KANSAS GAS AND ELECTRIC COMPANY

KMLNRC 84-118

Subj: Technical Specifications

# TECHNICAL SPECIFICATION CHANGES

FIGURE 3.2-3

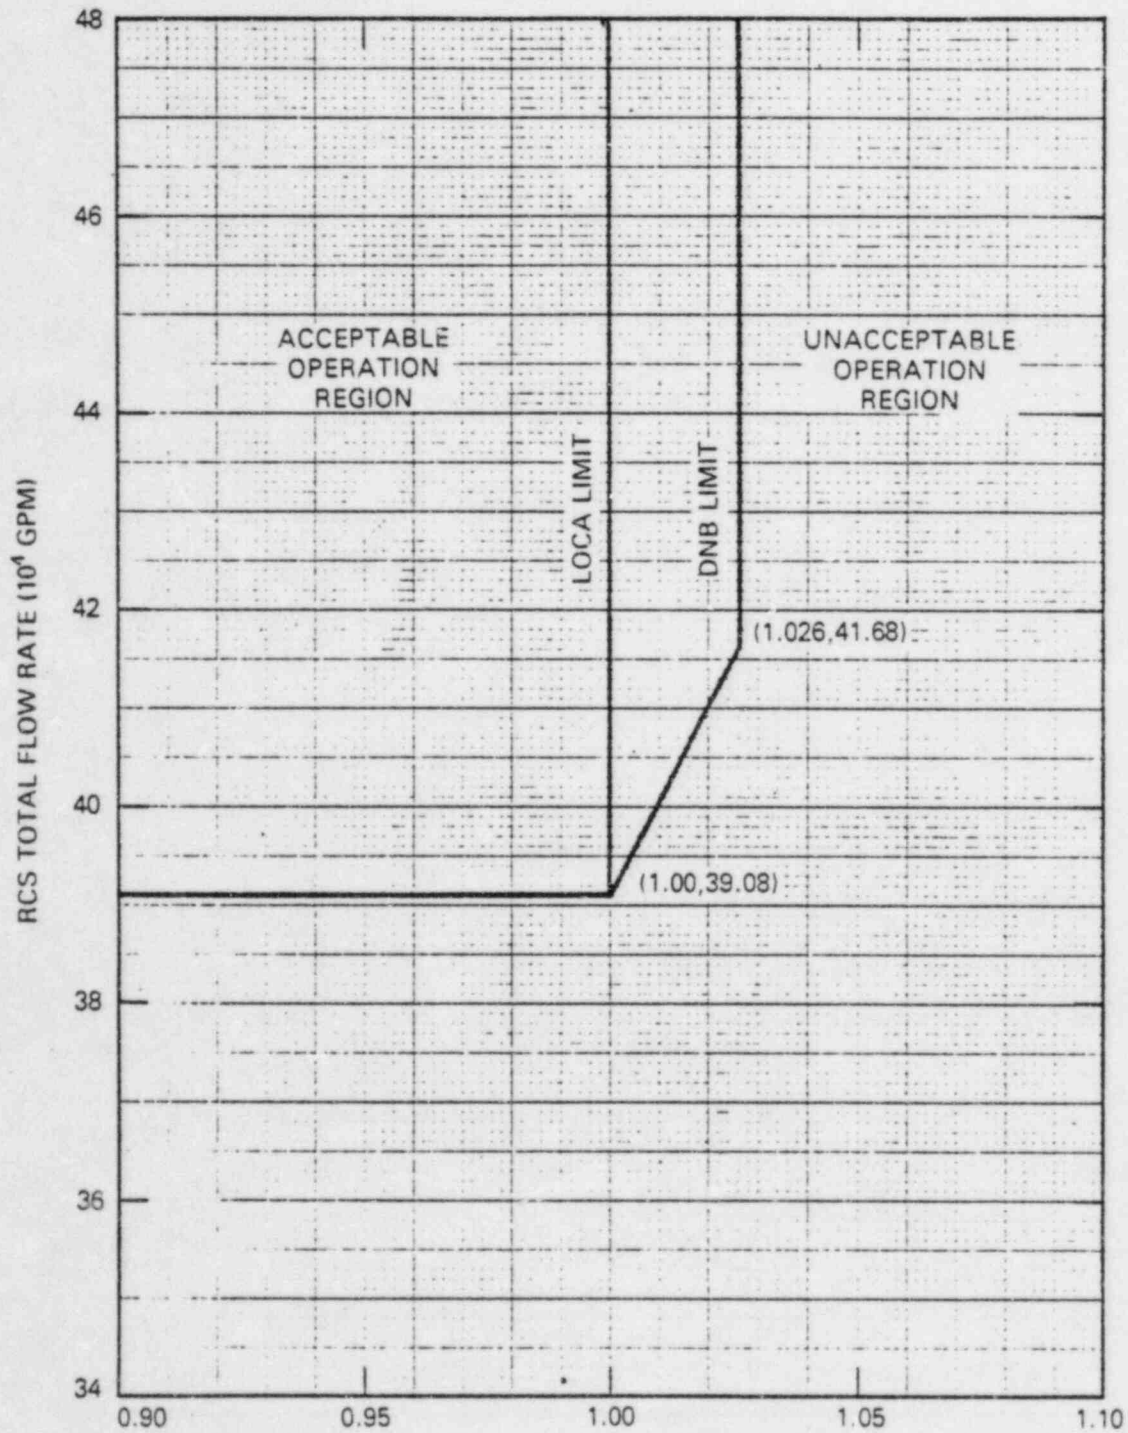
Page	Section	Reason for Change
3/4 2-9	Figure 3.2-3	Make Wolf Creek specific.
3/4 2-10	4.2.3.5	Consistent with Callaway T.S. Includes Wolf Creek specific instrument.
3/4 2-11	3.2.4	Consistent with Callaway T.S.
3/4 2-15	Table 3.2-1	Consistent with Callaway T.S.
3/4 3-2	Table 3.3-1 (6b & 6c)	Consistent with Callaway T.S.
3/4 3-3	Table 3.3-1 (12a & 12b)	Consistent with Callaway T.S.
3/4 3-4	Table 3.3-1 (19)	Consistent with Callaway T.S.
3/4 3-5	Table 3.3-1, Table Notations	Consistent with Callaway T.S.
3/4 3-6	Table 3.3-1 (Action 5)	Consistent with Callaway T.S.
3/4 3-6	Table 3.3-5 (Action 5 - deletion of Boron Dilution Techni- cal Specification)	Justification provided by KMLNRC 84-034, dated 3/16/84
3/4 3-7	Table 3.3-2 (1)	Consistent with Callaway T.S.
3/4 3-8	Table 3.3-2 (Heading & Item 12)	Consistent with Callaway T.S.
3/4 3-9	Table 4.3-1 (item 6 - deletion of note (12))	Justification provided by KMLNRC 84-034, dated 3/16/84

FIGURE 3.4-2  
REACTOR COOLANT SYSTEM HEATUP LIMITATIONS  
APPLICABLE UP TO 16 EFPY

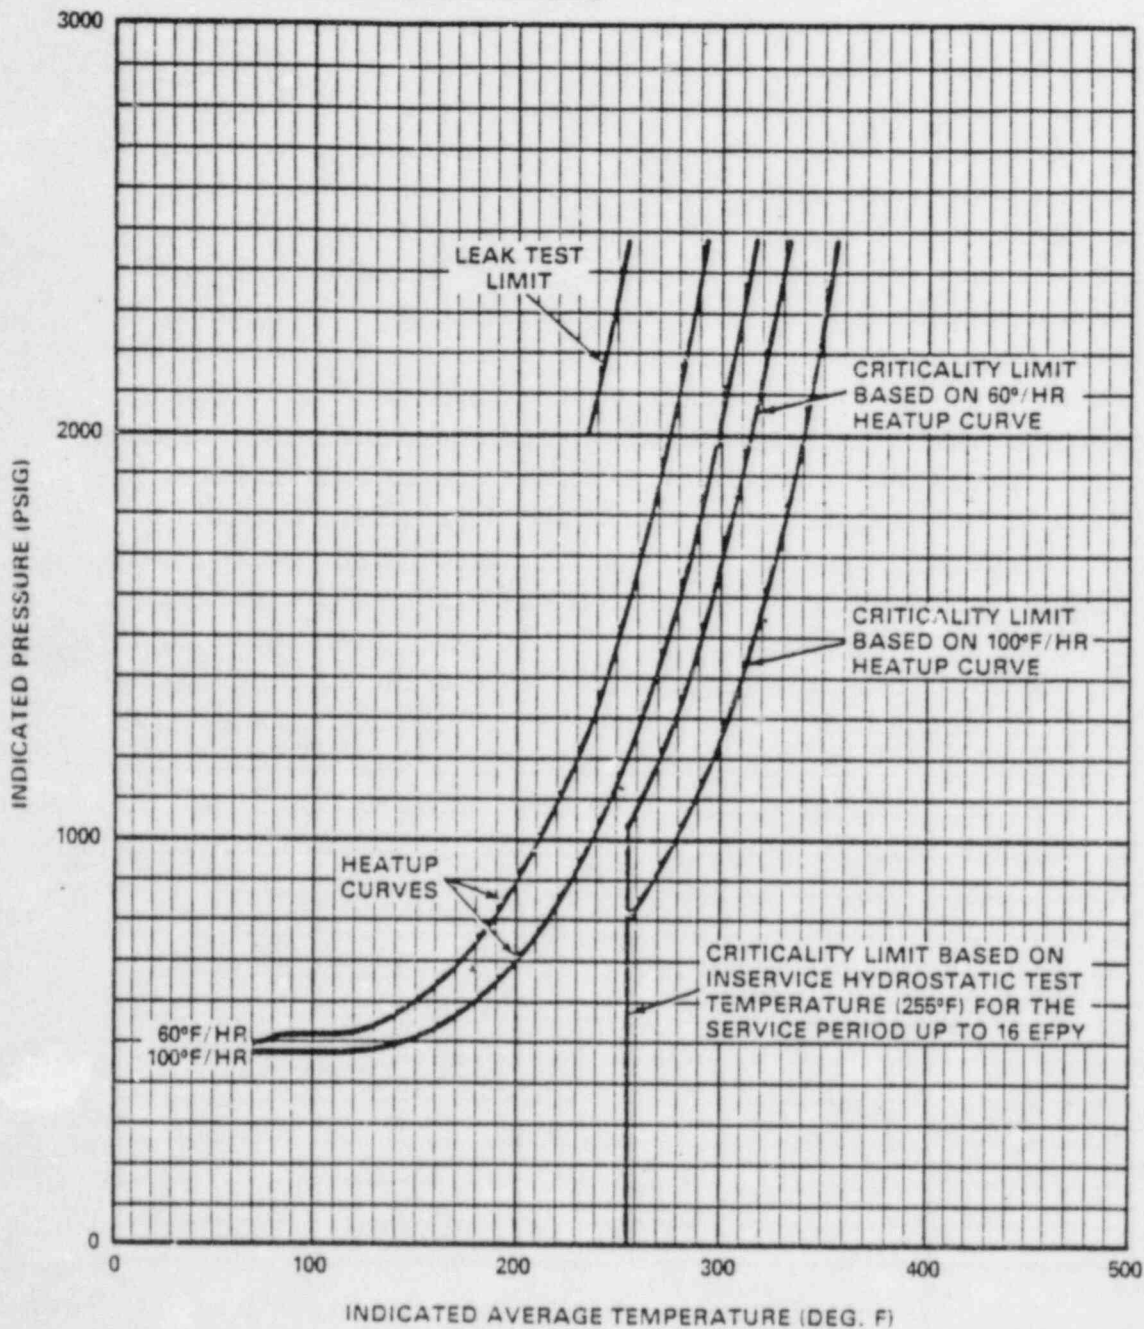
Page	Section	Reason for Change
3/4 4-29	4.4.9.1.2	Consistent with Callaway T.S.
3/4 4-30	Figure 3.4-2	Consistent with Callaway T.S.
3/4 4-31	Figure 3.4-3	Consistent with Callaway T.S. with Wolf Creek specific notch in curve.
3/4 4-32	Table 4.4-5	Consistent with Wolf Creek analysis
3/4 4-34	3.4.9.3	Consistent with Callaway T.S. and justification provided
3/4 4-34	3.4.9.3 (a, b, & c and Actions a, b, & c)	Consistent with Callaway T.S. and justification provided.
3/4 4-35	4.4.9.3.2 & 4.4.9.3.3	Consistent with Callaway T.S.
3/4 4-36	Figure 3.4-4	Consistent with Callaway T.S.
3/4 5-1	3.5.1.a and Action b	Consistent with Callaway T.S.
3/4 5-2	4.5.1.1 (b,c,&d)	Consistent with Callaway T.S.
3/4 5-3	3.5.2 (* note)	Consistent with Callaway T.S.
3/4 5-5	4.5.2.e.1)	Consistent with Callaway T.S.
3/4 5-6	4.5.2.h.3) & 4.5.2.i	Consistent with Callaway T.S.
3/4 5-7	3/4.5.3 (Heading)	Consistent with Callaway T.S.
3/4 5-7	3.5.3.d and 3.5.3 (Action a & c)	Consistent with Callaway T.S.

FIGURE 4.7-1

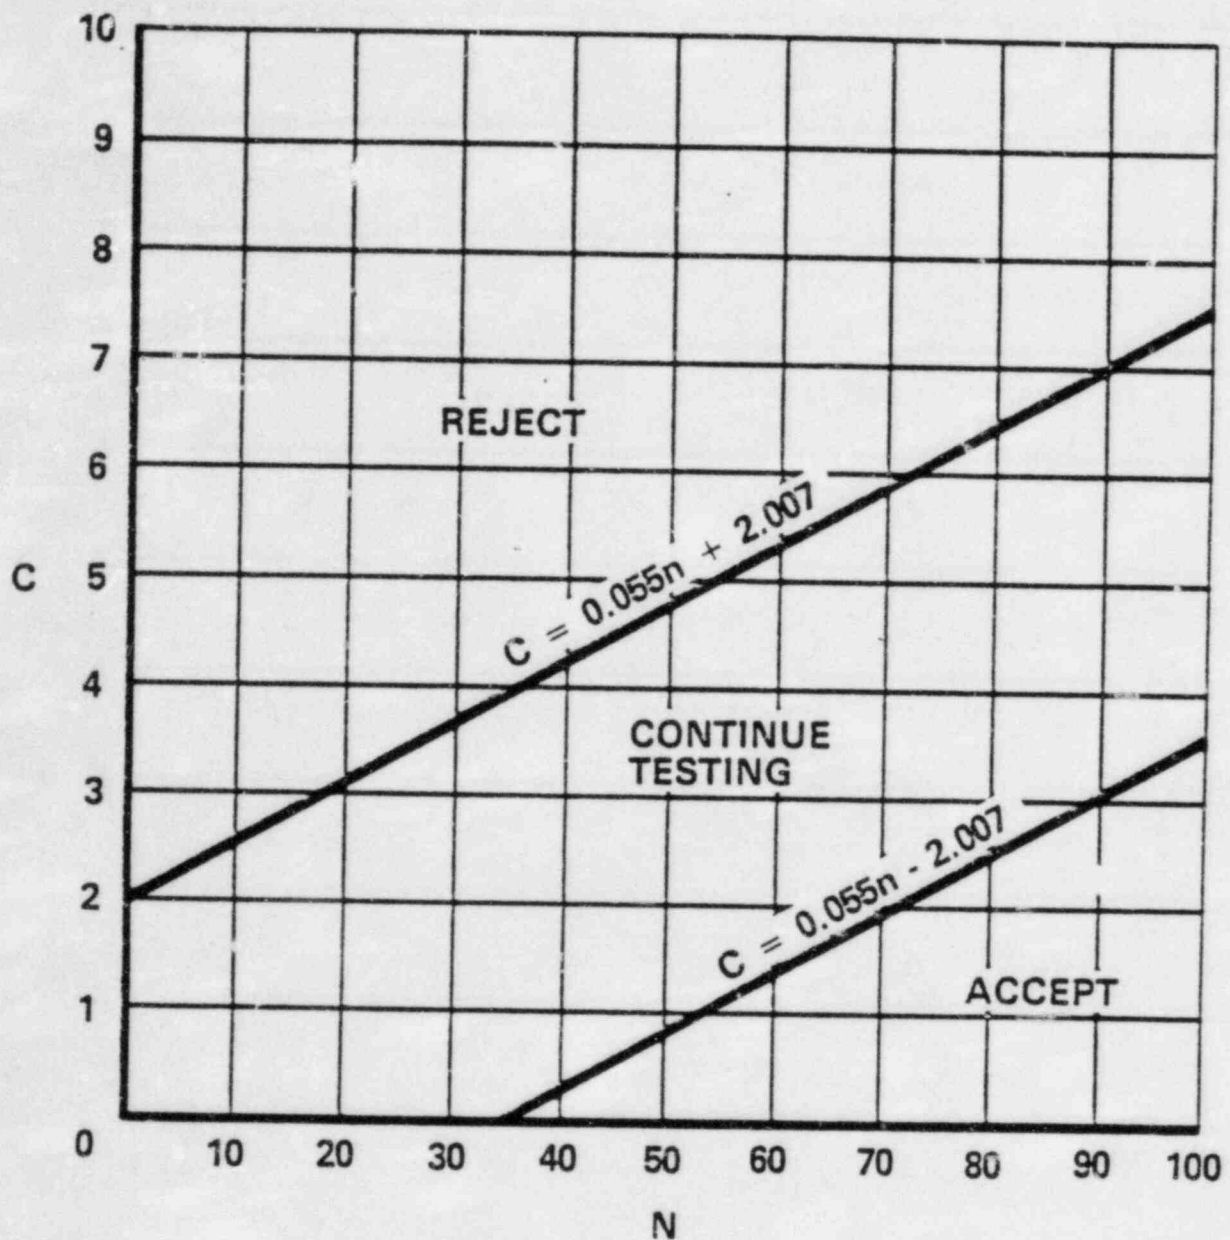
*Insert* > Figure 4.7-1 was developed using "Wald's Sequential Probability Ratio Plan" as described in "Quality Control and Industrial Statistics" by Acheson J. Duncan.

FIGURE 5.1-2  
LOW POPULATION ZONE

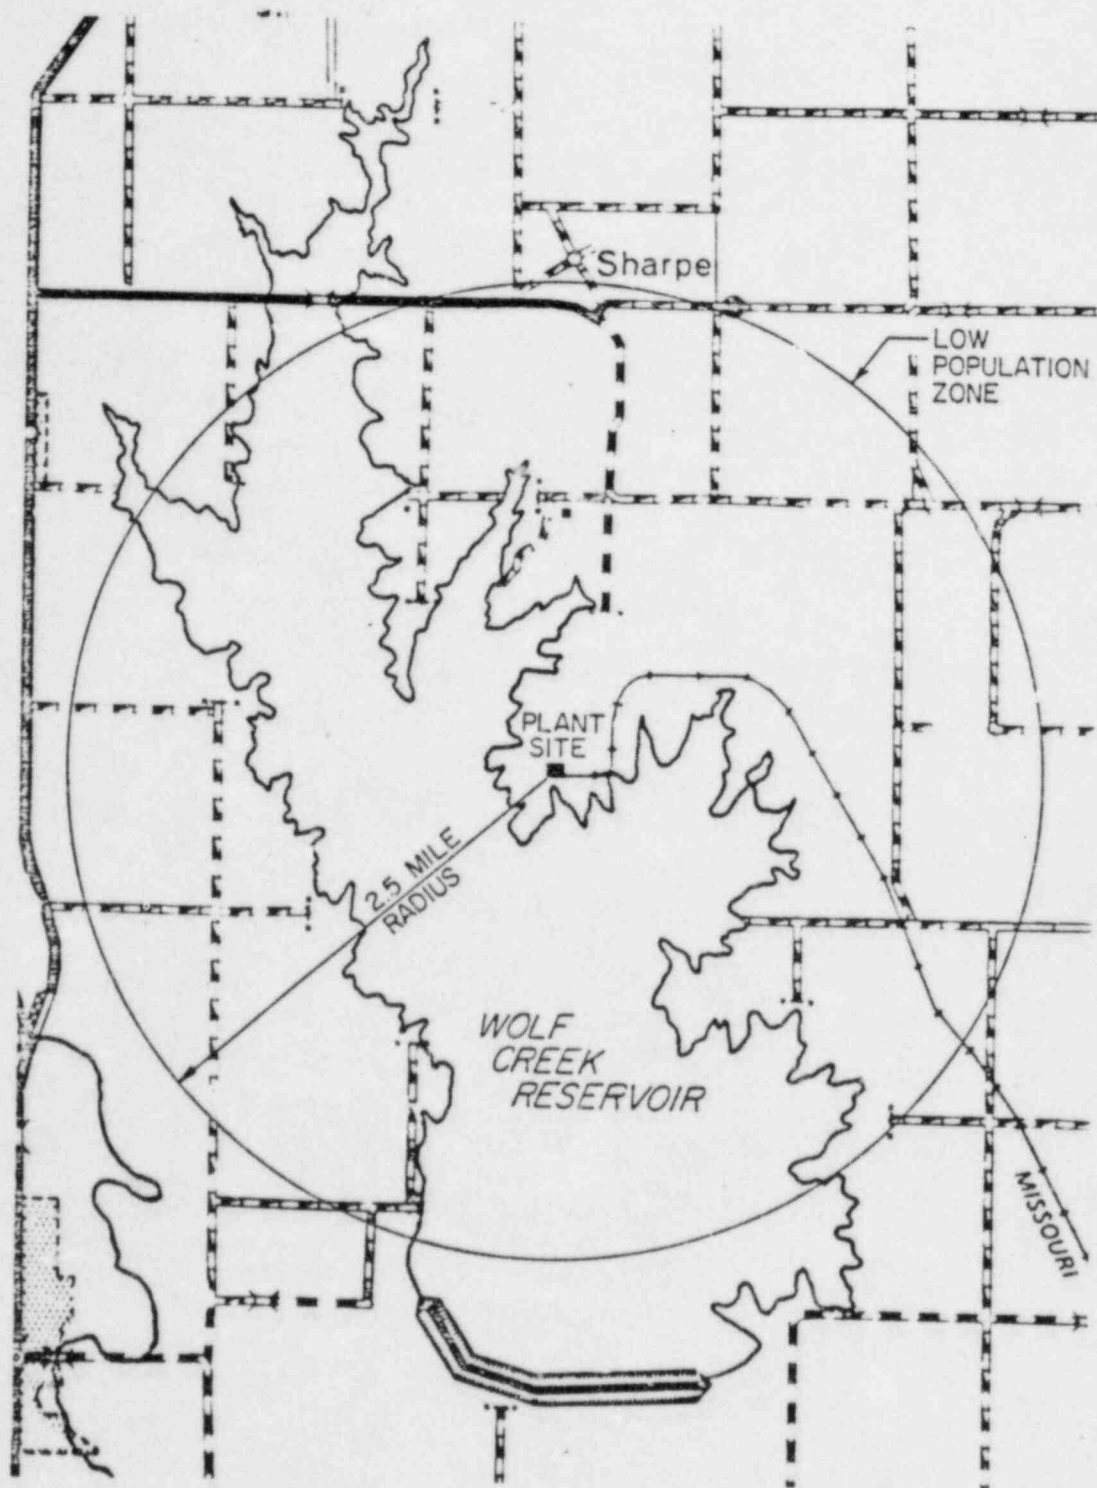
Figure 5.1-2

Justification -

This figure was revised for clarity.

Figure 5.1-3  
Boundary for Gaseous Effluents

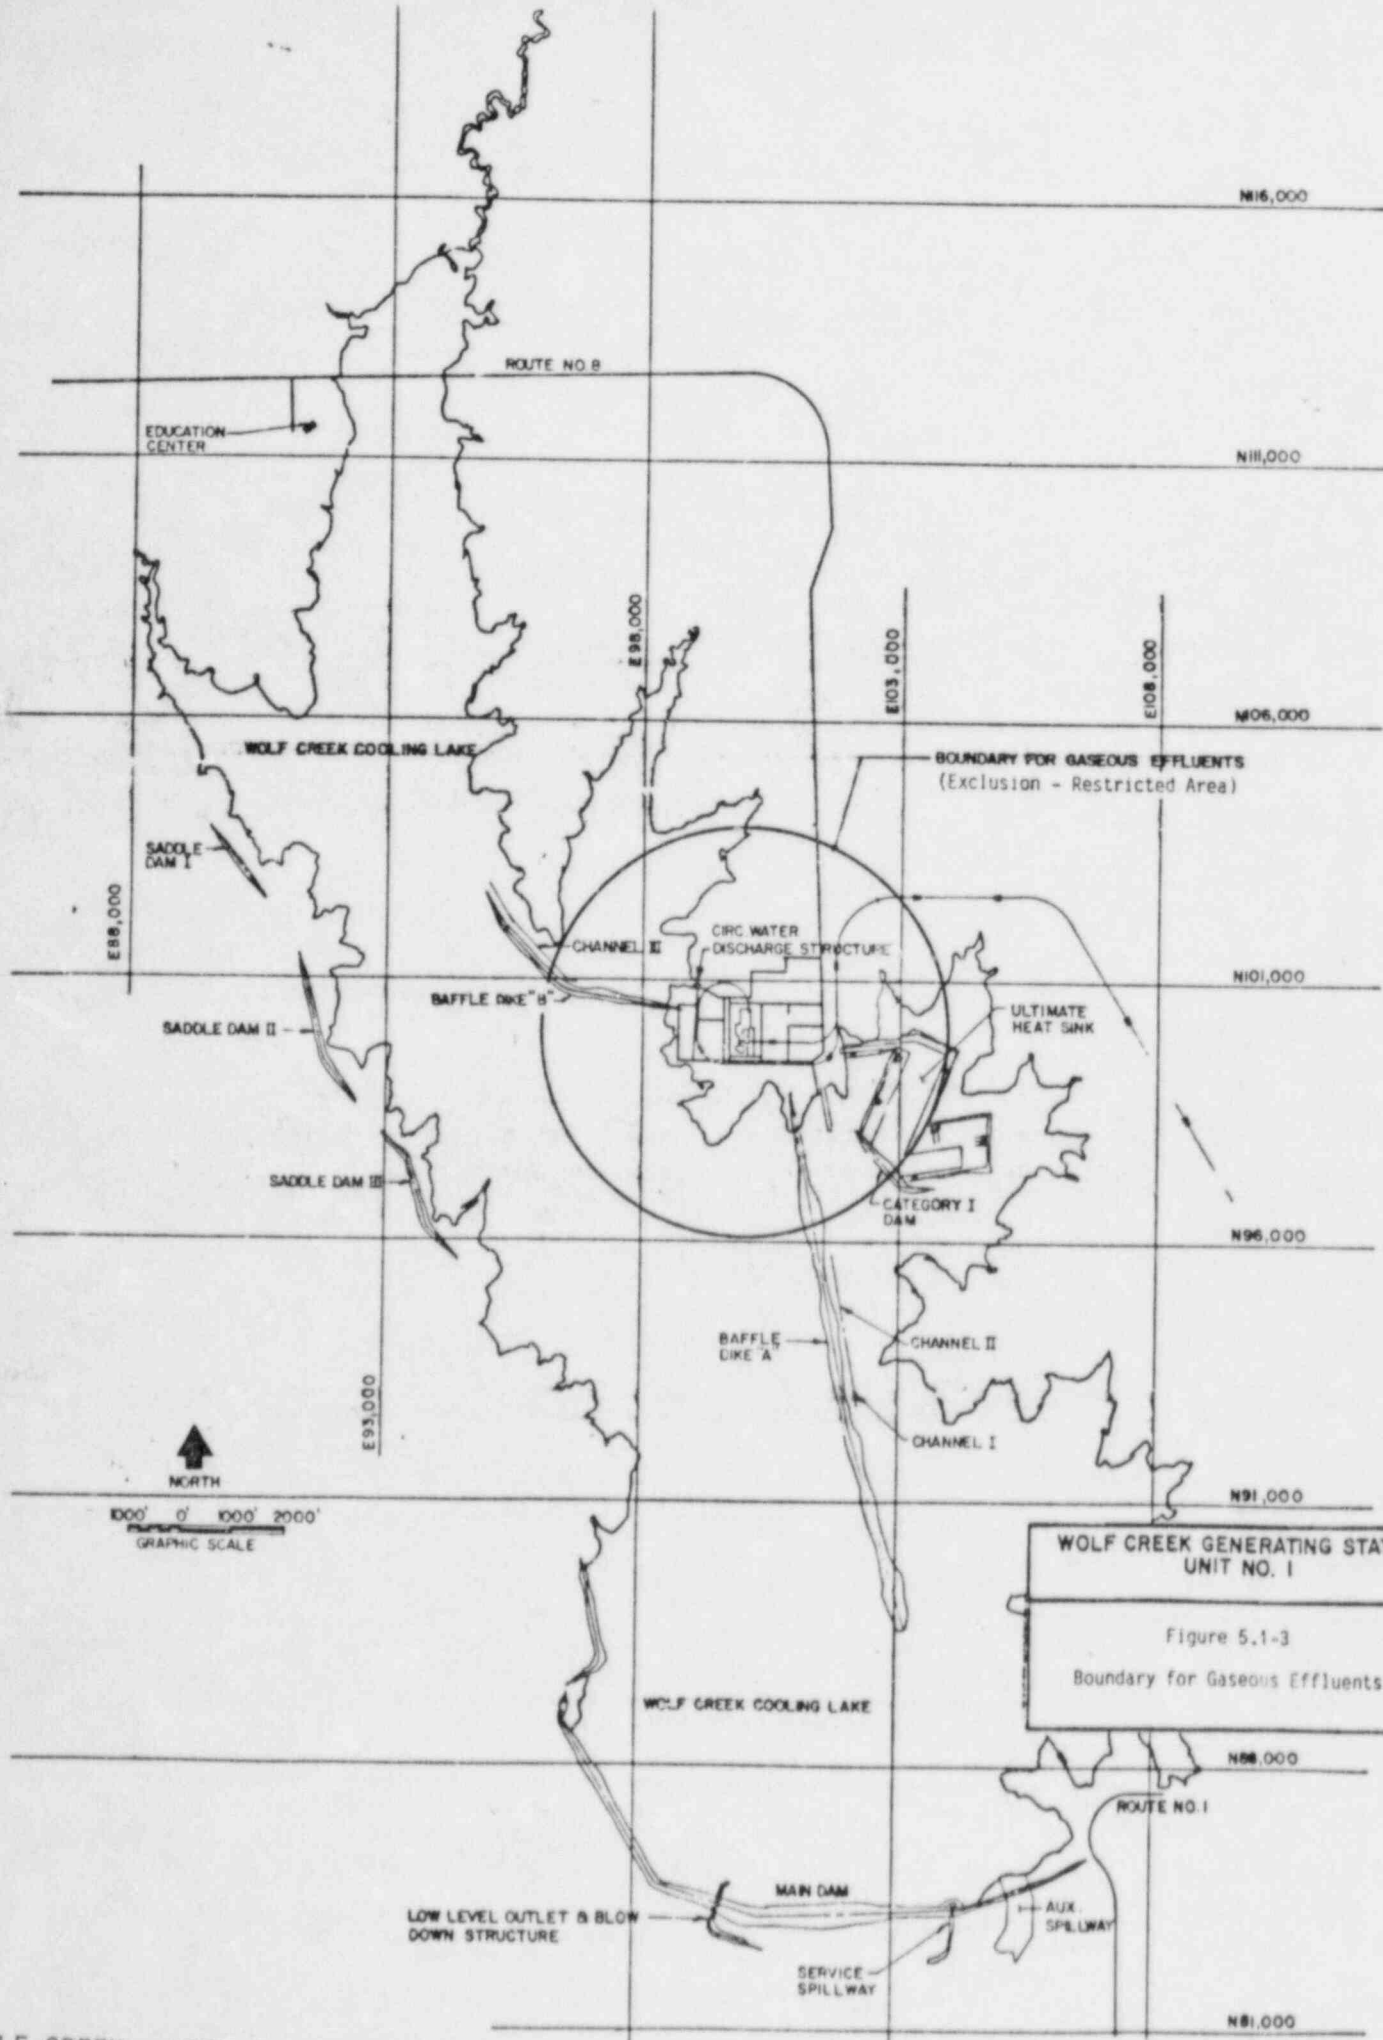
Figure 5.1-3

Justification -

The figure was revised for clarity.
